PLANNING COMMISSION: OAK HILL, TENNESSEE

Project Explanation: Building New Single family Home

RE: Site Plan Review
Lot 39, Inns of Granny White Subdivision
City of Oak Hill, Tennessee
AG & E File Number: 2022-025

We have completed our review of the revised Steep Slope site plan for the proposed new home located at 1167 Travelers Ridge. Please see below for engineering comments.

GRADING AND UTILITY PLAN

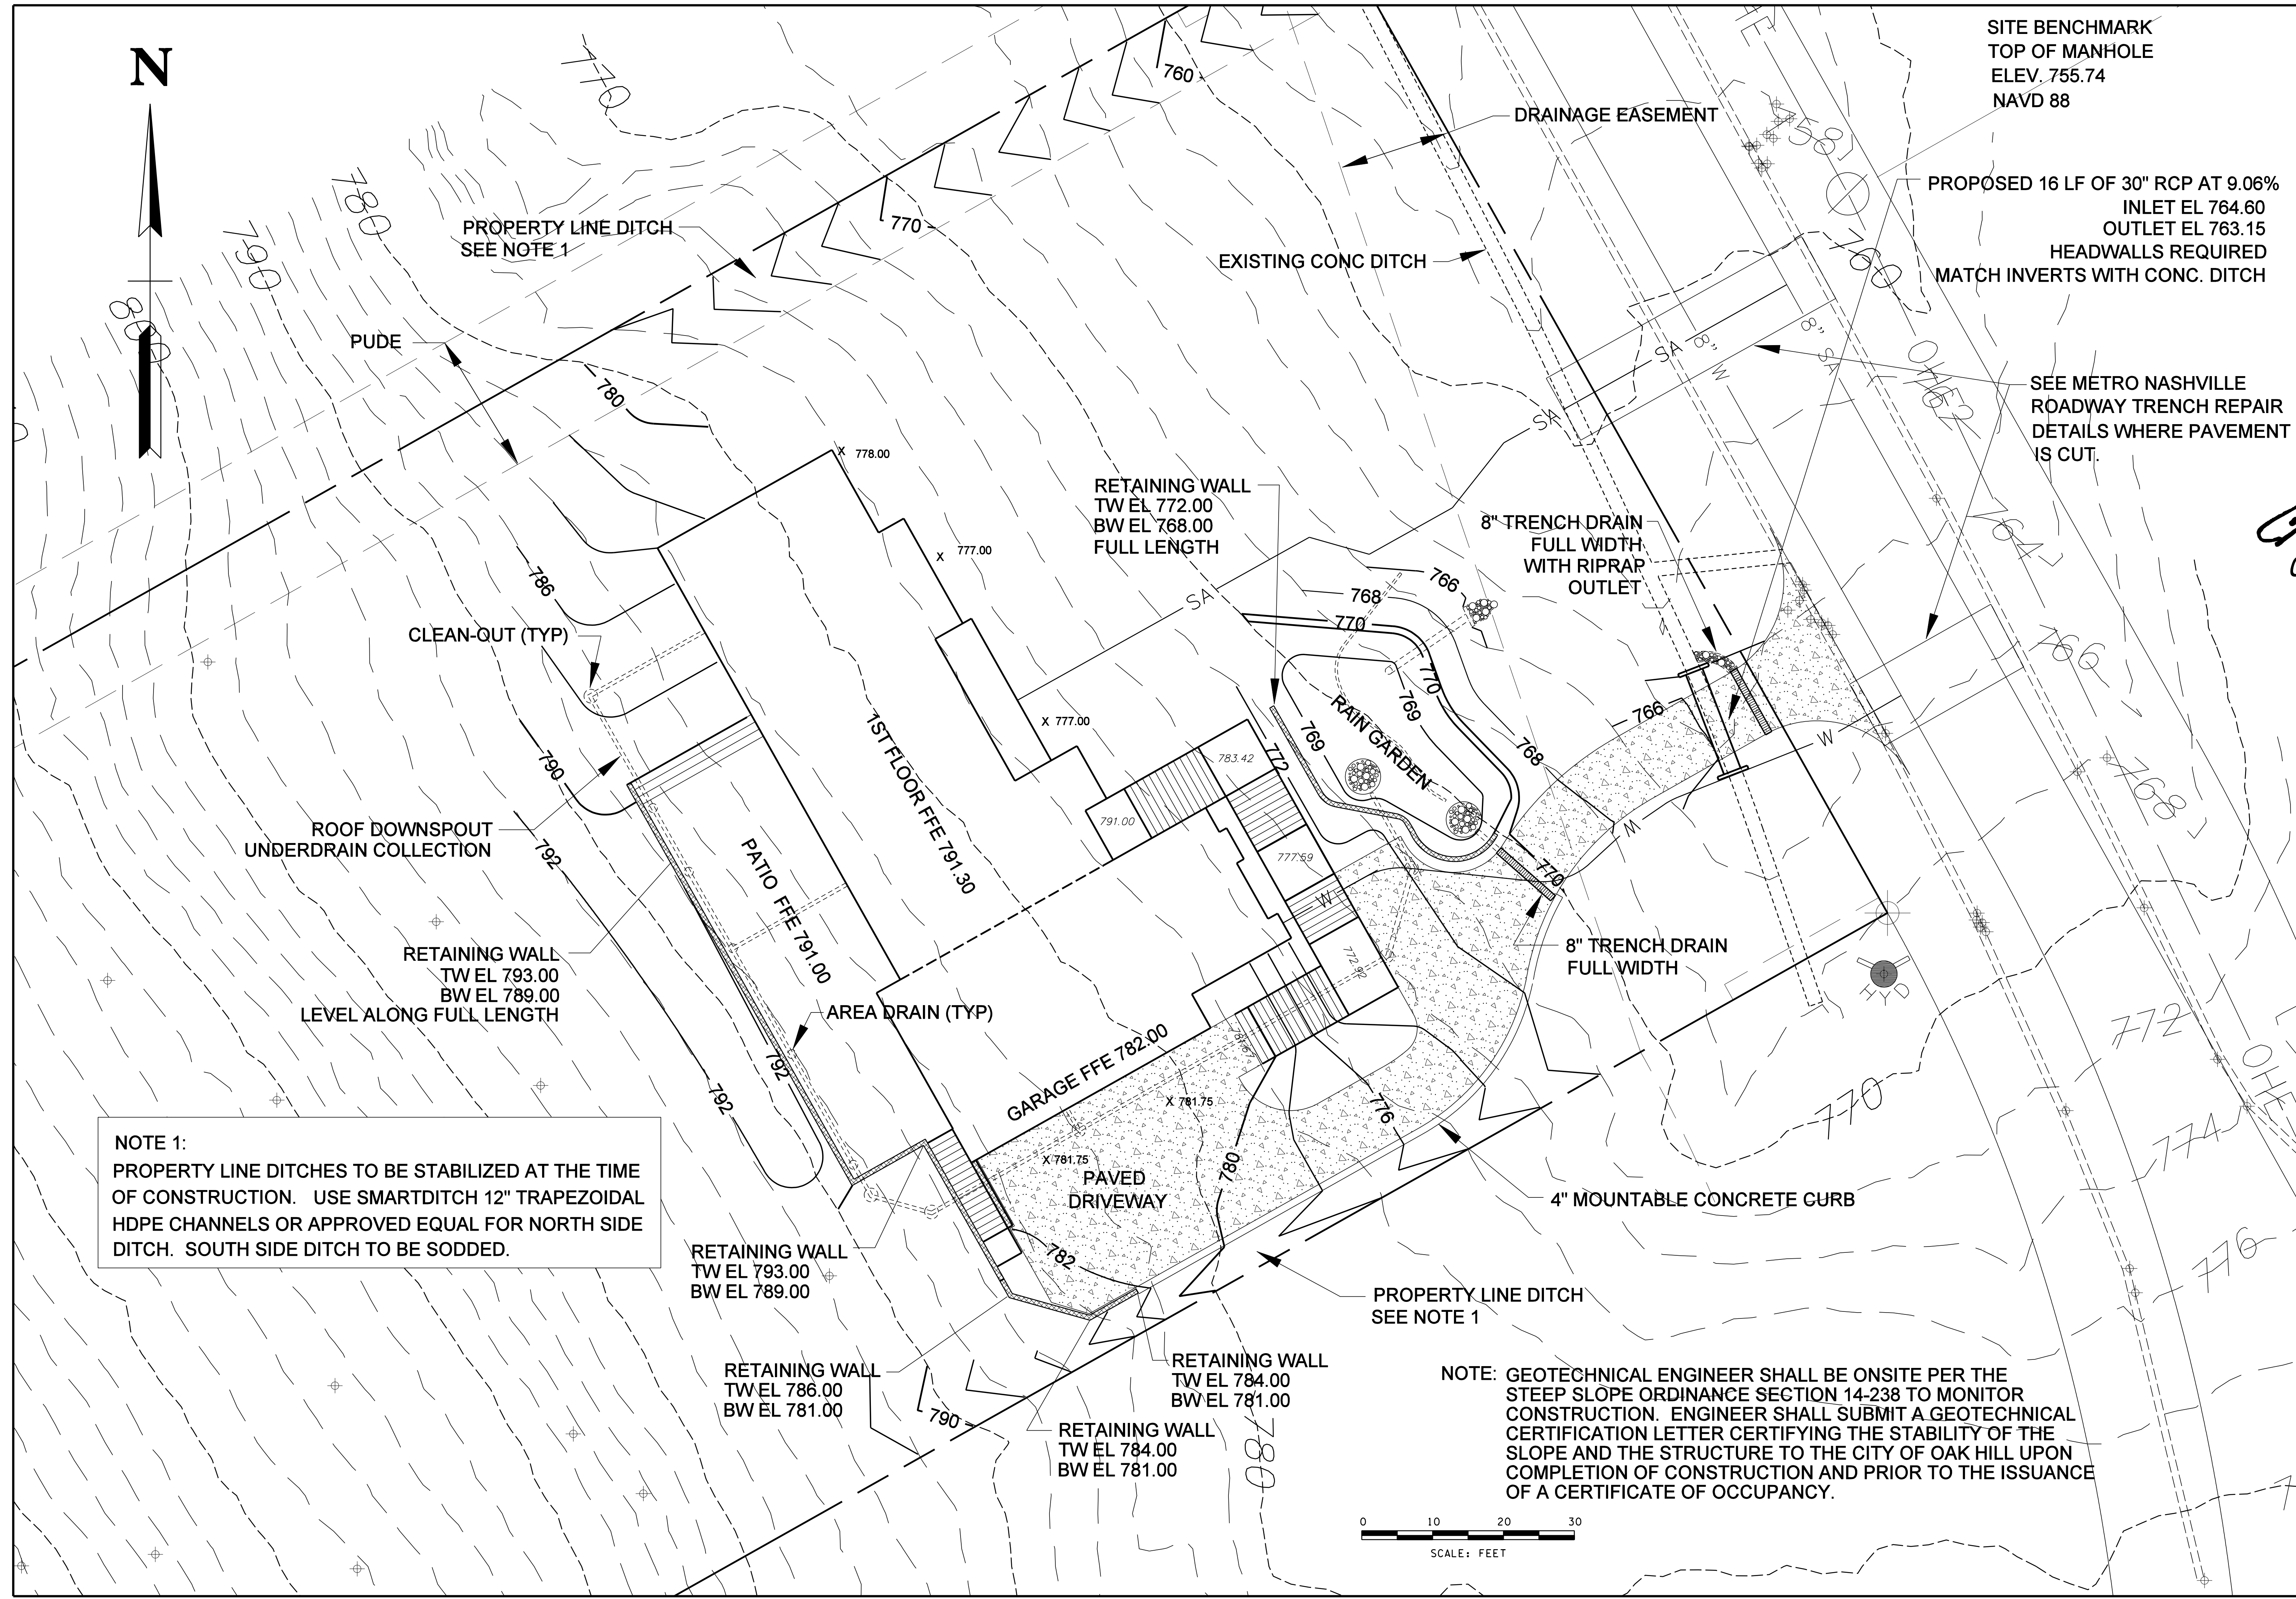
9. Provide street cut areas around utility connections for sanitary and water, reference metro street cut detail on plans.
 - a. **Provided and noted. Show sawcut area and limits of disturbance for water line connection. PROVIDED, SEE SHEET 4**

10. Provide more spot grades in driveway and around outside of house.
 - a. **Outstanding comment. Need more spot grades around the house and driveway. PROVIDED SHEET 4**

RAIN GARDEN DETAIL
NEW RESIDENCE
 Parcel ID 14507007300
 1167 Travelers Ridge Drive
 Nashville, TN 37220
 City of Oak Hill
 Davidson County, TN
 34th Council District

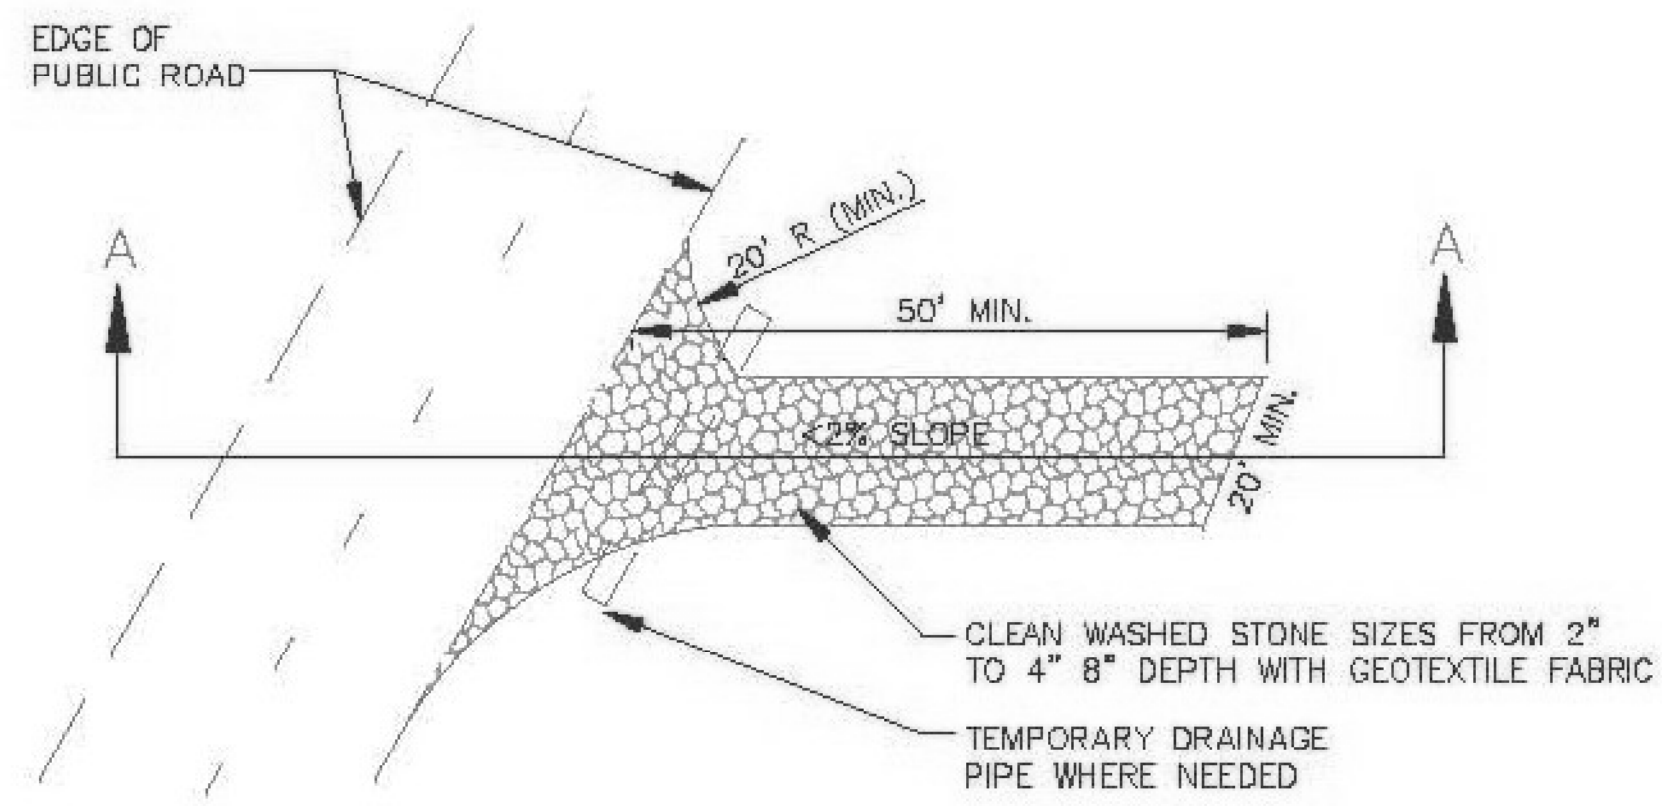
- a. Show drainage area to rain garden. Is some of the driveway going towards the rain garden. Rain garden must be sized for the drainage area not just for the added impervious area. **DONE ✓**

- 20. Provide outlet protection for the daylight end of the MFD pipe.
 - a. Show outlet protection for rain garden. How will rain garden outlet – must provide underdrains and show outlet for underdrains. **DONE ✓**

- b. Provide site specific detail for the rain garden with elevations of each layer and materials. **DONE ✓**
- 21. Show downspout locations and routing to MFDs.

TREE REMOVAL AND PROTECTION PLAN
NEW RESIDENCE
 1167 Travelers Ridge Drive
 Nashville, TN 37220
 34th Council District
 Parcel ID 14507007300
 City of Oak Hill
 Davidson County, TN

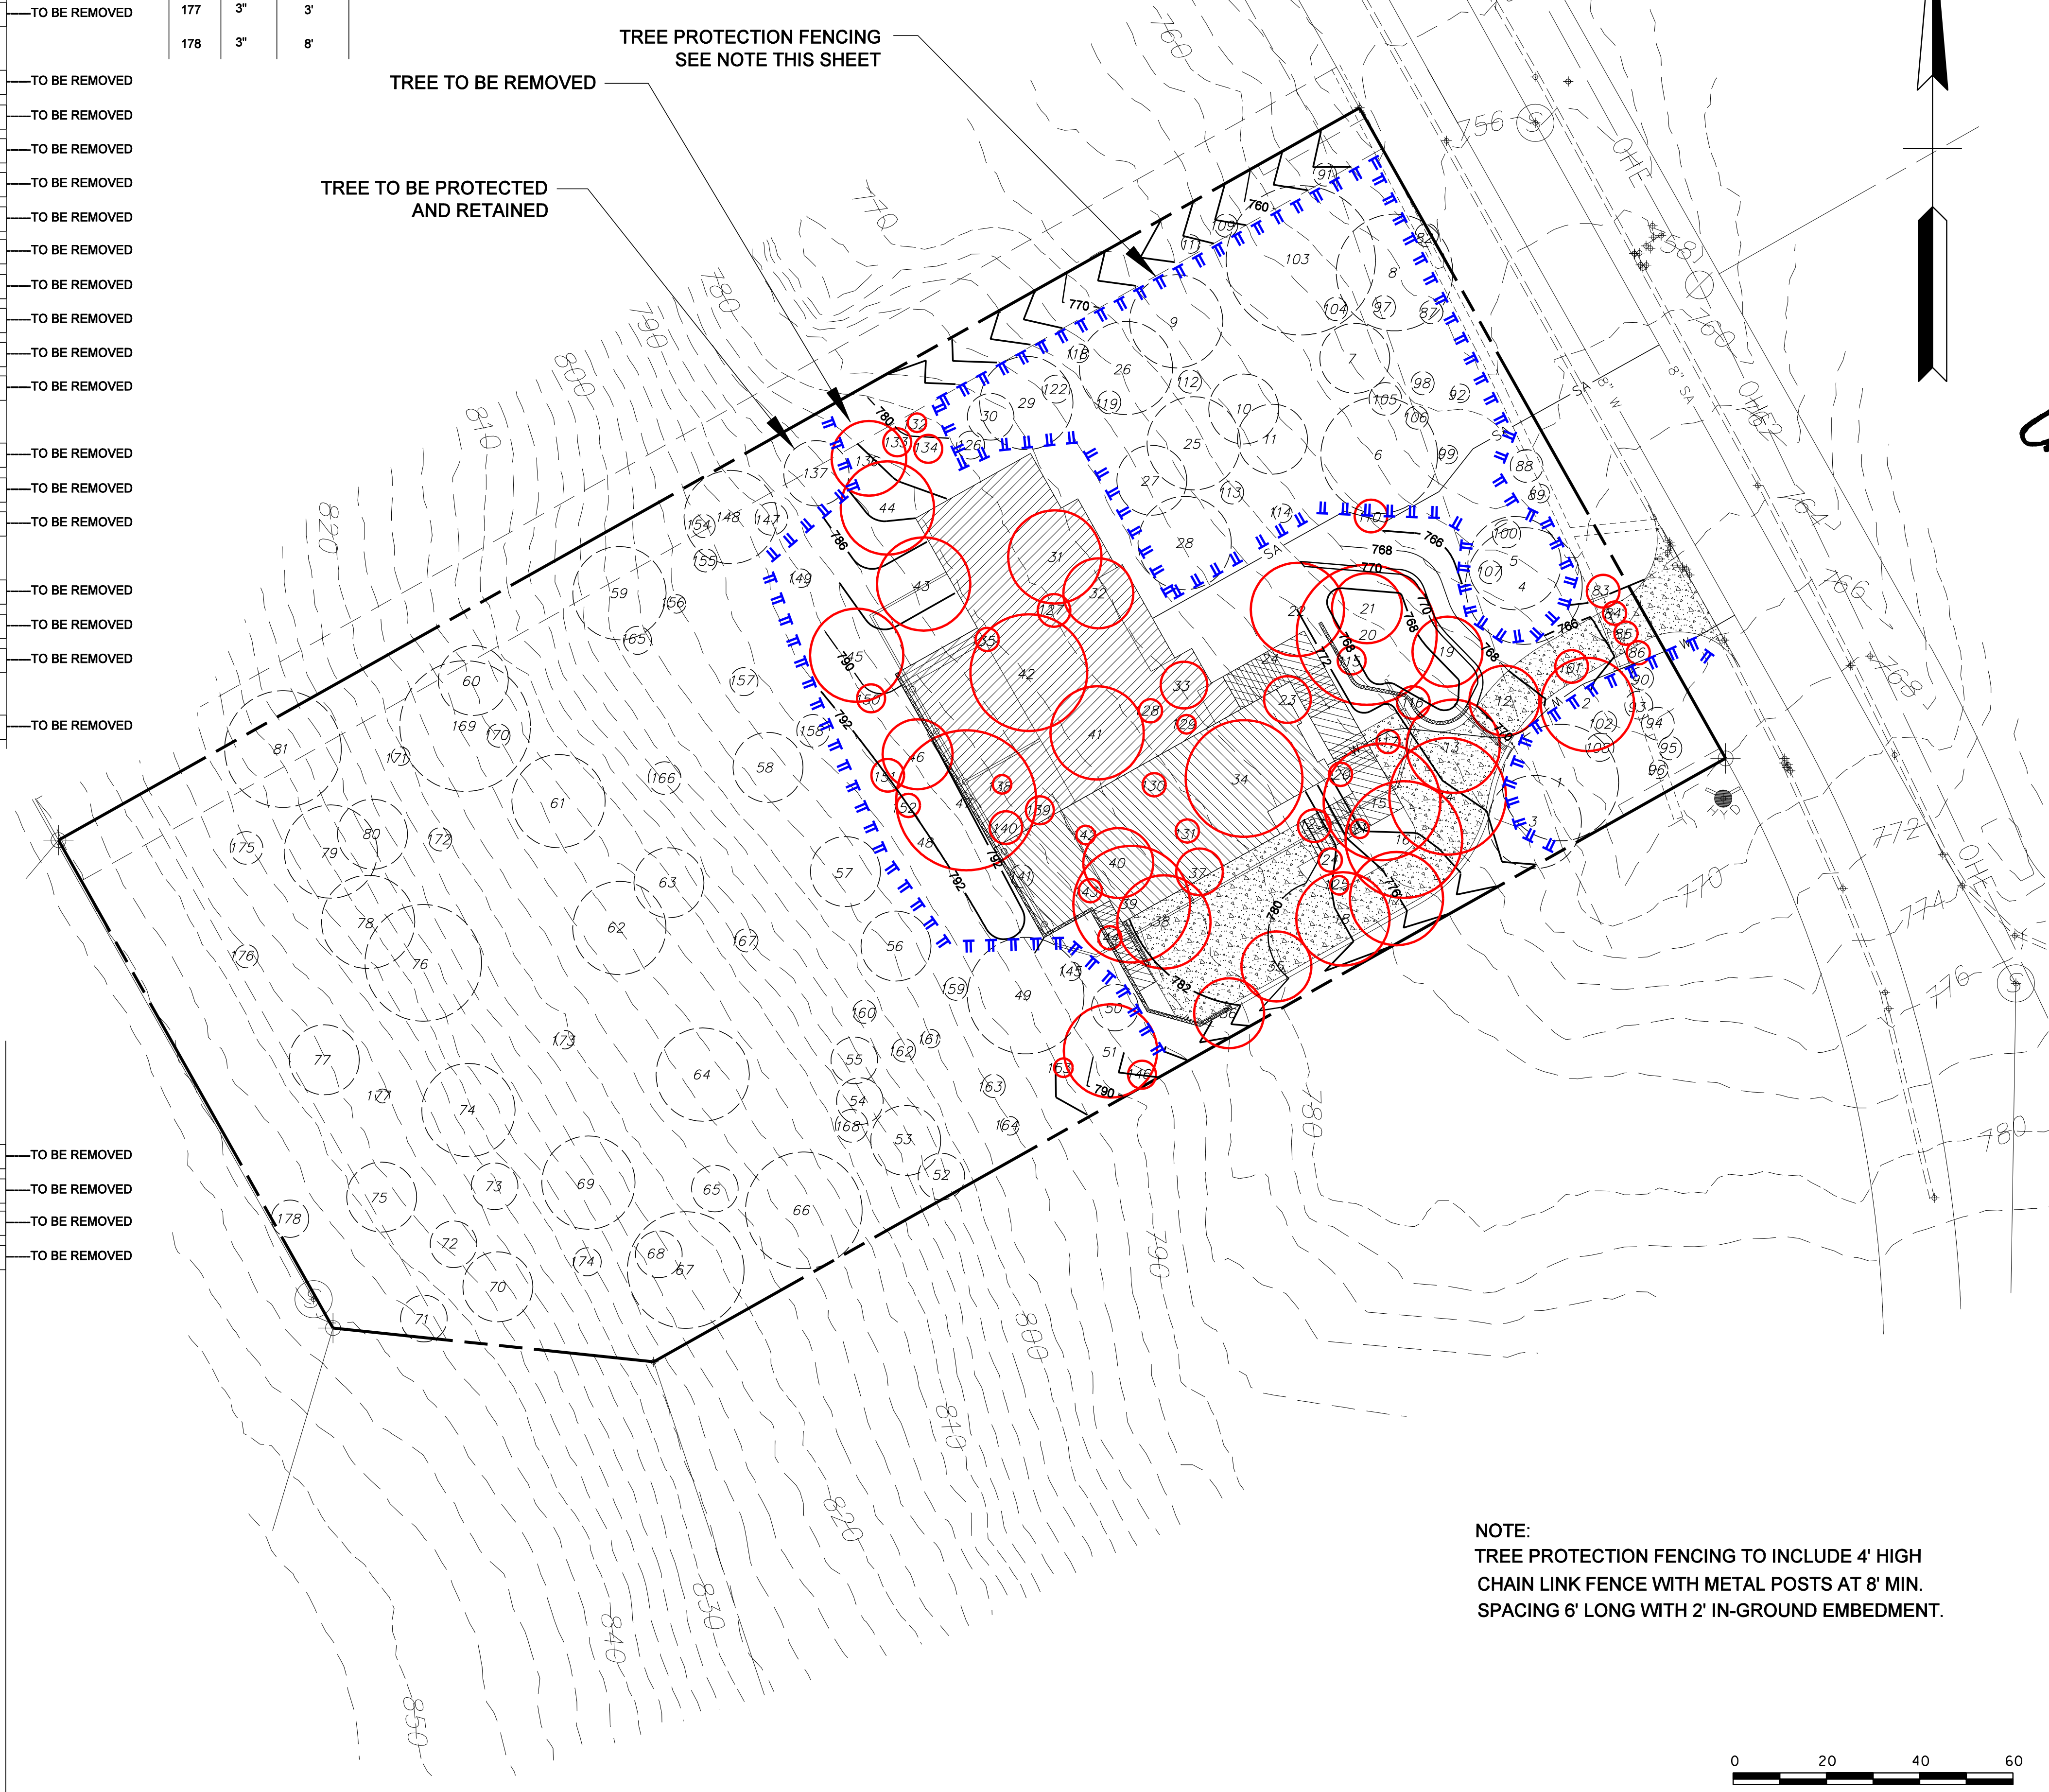
- a. **Provided. ✓**
- 22. Note trees that are to be removed on the plans.
 - a. **Provided. ✓**
- 23. Tabulate the trees that are to be removed in a table and provide the total caliper inches that are to be removed.

- a. **Provided. ✓**
- 25. Need to show tree protection fencing around all trees that are to be saved. Provide detail of tree protection fencing.
 - a. Provided. Show detail for tree protection fence. **DONE ✓**
